**Figure 4: North-south elevation showing proposed modifications compared to the approved scheme (green shows areas of reduced building envelope / yellow shows areas of increased building envelope) (Source: proponent's modification request)**

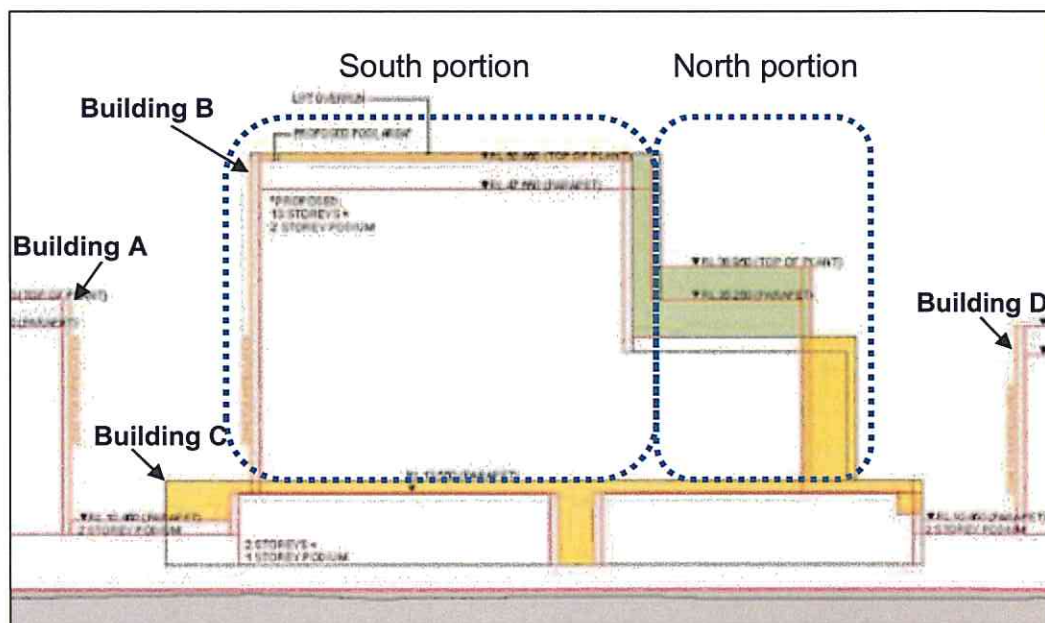
The proposal seeks to amend the height of Buildings B and C as outlined in **Table 7** and shown in **Figure 4**.

The proponent states that the increased height to Building B will accommodate a single storey apartment within an additional level, and also a balustrade and lift overrun to facilitate access to a communal terrace and communal pool. The increased height to Building C will allow for skillion

The Department notes that the southern portion of Building B, as approved, has an overall maximum height of RL 50.85 metres to the top of rooftop plant. The proponent seeks to rationalise plant and increase the parapet height to match the approved plant height to enable an additional storey of residential uses. The Department has previously supported the increased parapet heights across the residential precinct up to the approved plant height. Term of Approval A8 allows minor variations to the maximum parapet height where:

The Department is satisfied in this case that the increased parapet height is acceptable as:

- it does not exceed the maximum plant height;
- overshadowing impacts of the additional height will be minor, falling onto the site and will not impact on the ability for a minimum of 70% of apartments to achieve at least two hours of solar access in midwinter;
- the increase in height will result in a parapet height generally consistent with Buildings E1 and G, which is considered acceptable in the context of the residential precinct and its central location within the site;
- the detailed design of the additional storey can be considered by Council in a future development application to ensure it is well integrated into the design of the building.

The Department supports the 1.45 metre increase in the parapet height of Building C, given that:

- at two storeys above a single storey podium, Building C is considerably lower than all the other buildings in the residential precinct and the proposed increase is minor in the context of the surrounding buildings;
- Building C is visually screened from Captain Cook Drive by Building A and the mangroves located in the riparian zone;
- the proposal to incorporate skillion roofs on Building C would improve the building articulation, improve the potential design quality of the façade that fronts onto the riparian zone and improve solar access to the upper floors;
- the proposal will not cause any significant additional overshadowing and will not affect the ability for at least 70% of apartments to achieve two hours solar access in mid winter.

Figure 5: Comparison of modifications to the Buildings B and C (approved left and proposed right)

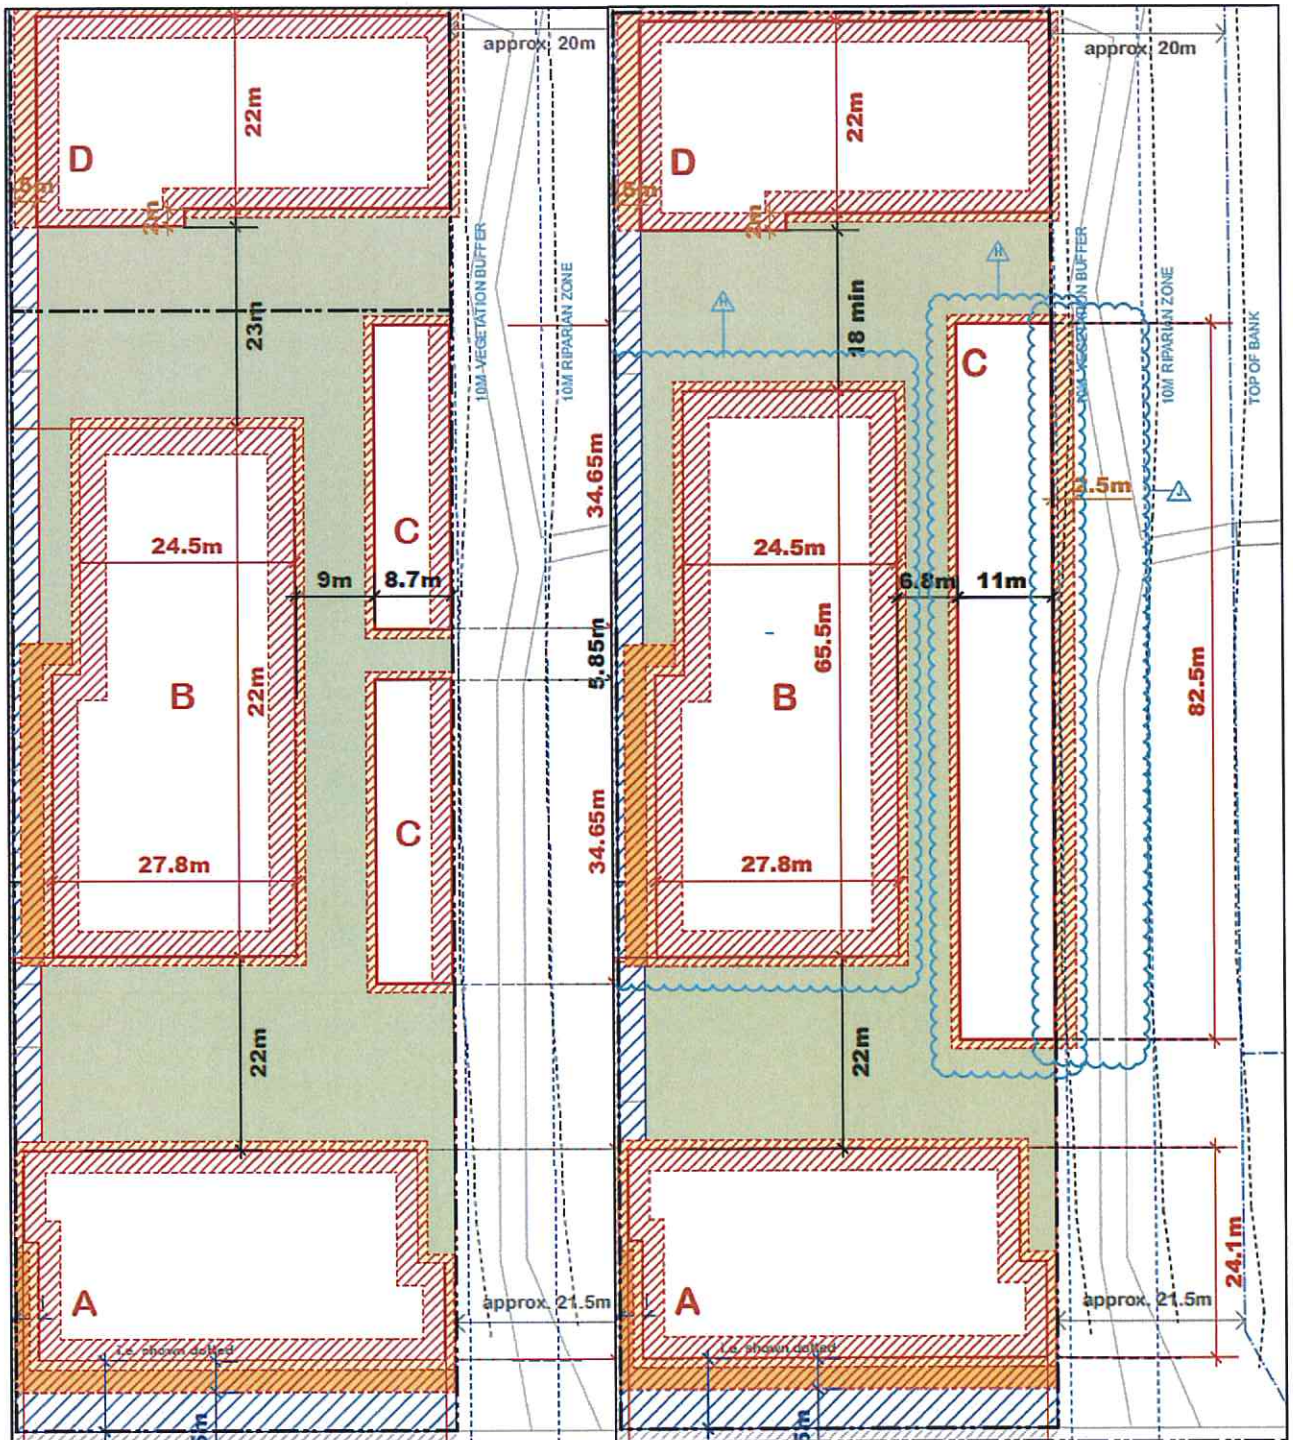
- extend the northern building envelope of Building B northwards by five metres; and
- combine the two individual elements of Building C into a single envelope with a length of 82.5 metres and a width of 11 metres (**Figure 5**).

In its submission, Council raised a concern that the separation distance between Buildings B and C and B and D would be inconsistent with the *SEPP 65 Apartment Design Guide (ADG)*, and would result in compromised privacy, solar access, ventilation and internal amenity. The Department notes that this application was submitted prior to the notification of the ADG on 17 June 2015 and its commencement on 17 July 2015. Notwithstanding, the Department notes that the guidance for building separation in the ADG is consistent with the Residential Flat Design Code (RFDC) which recommends the following:

The proposed northern extension of Building B will reduce the separation between Building B and D from 23 to 18 metres. However, the proposed 18 metre separation remains consistent with both the RFDC and the ADG as both of these buildings are eight storeys in height in this location (six storeys above the two storey podium). The Department is therefore satisfied that adequate privacy and internal amenity can be provided to apartments in these buildings. The proponent has also advised that apartments will be capable of achieving solar access and cross ventilation in accordance with the recommendations of the RFDC/ADG.

The proposed modifications to Building C will reduce the separation between Building C and B and Building C and D to 6.8 metres and 11 metres respectively. Noting that Building C is less than four storeys in height, and the proponent has confirmed that no windows are expected to be provided to the western elevation, a minimum of nine metres separation would be required between habitable rooms/balconies in Building B and the potentially blank façade of Building C. A 12 metre separation would be required between Buildings C and D. Therefore the 6.8 and 11 metre separation does not meet the RFDC/ADG recommendation.

However, the Department considers that reduced separation is acceptable in this case given that:

- the building presents as a single storey building in this location (**Figure 6**);
- there are likely to be no windows on the western elevation;
- despite the one metre shortfall between Building C and D, the future development application for the buildings can provide privacy measures such as offset windows or screening to eliminate any privacy concerns; and
- it is unlikely to significantly impact on solar access, ventilation, privacy and internal amenity.

Figure 7: Indent in building envelope to be removed

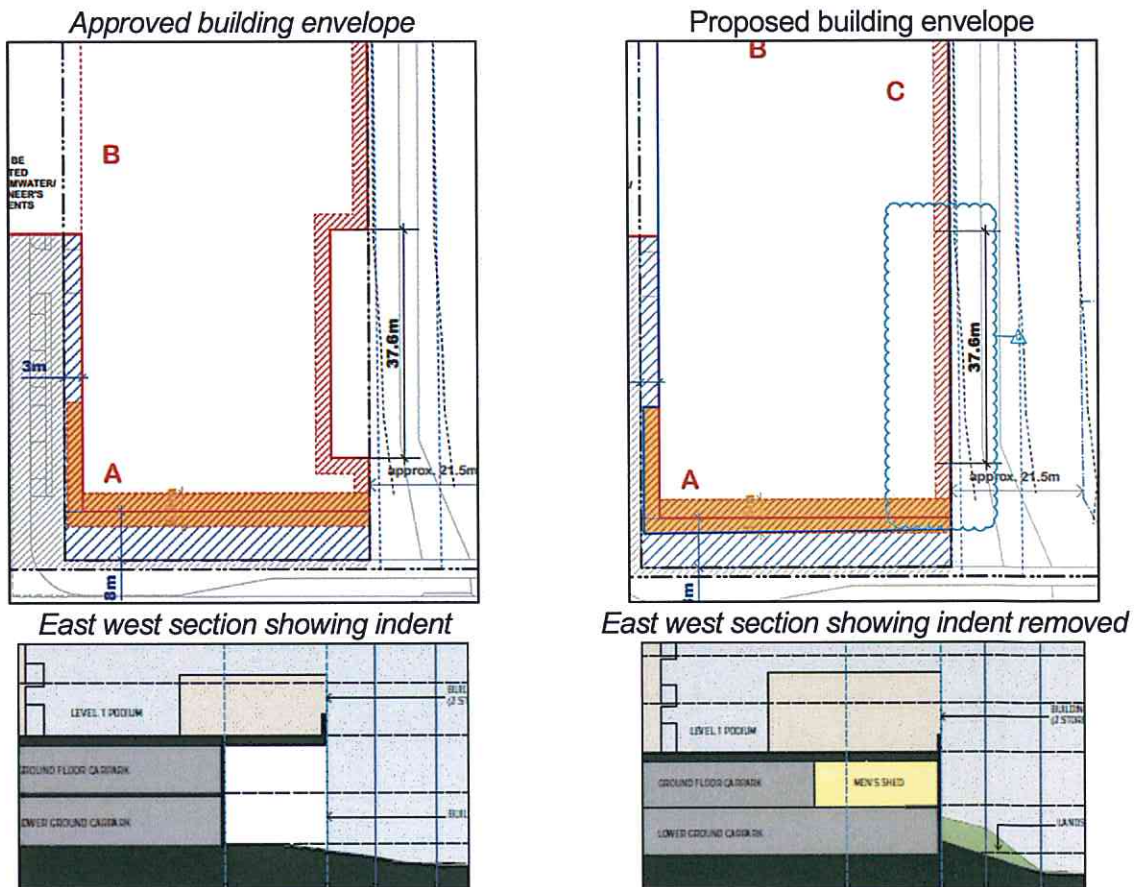
The proposal seeks to remove an indent from the building envelope in the south-eastern corner of the lower ground and ground levels of the podium (car park) (**Figure 7**).

The proponent has advised that this indent was originally intended to articulate this elevation and provide exposure to the car park. However, the proponent now seeks to amend the building footprint in this location to increase the car park at the lower ground level and provide an active frontage, through the provision of a future 'Men's Shed' at ground level. This facility would offer additional amenity to residents.

The Department has considered this a minor design modification and is satisfied that it will result in a better design outcome for this part of the building, as it will:

- increase activation of this part of the podium frontage onto the riparian corridor;
- improve safety and security;
- will be partially screened by mounding and landscaping ground level; and
- will provide additional floor space for the car park and allow the future provision of a Men's Shed (subject to separate approval).
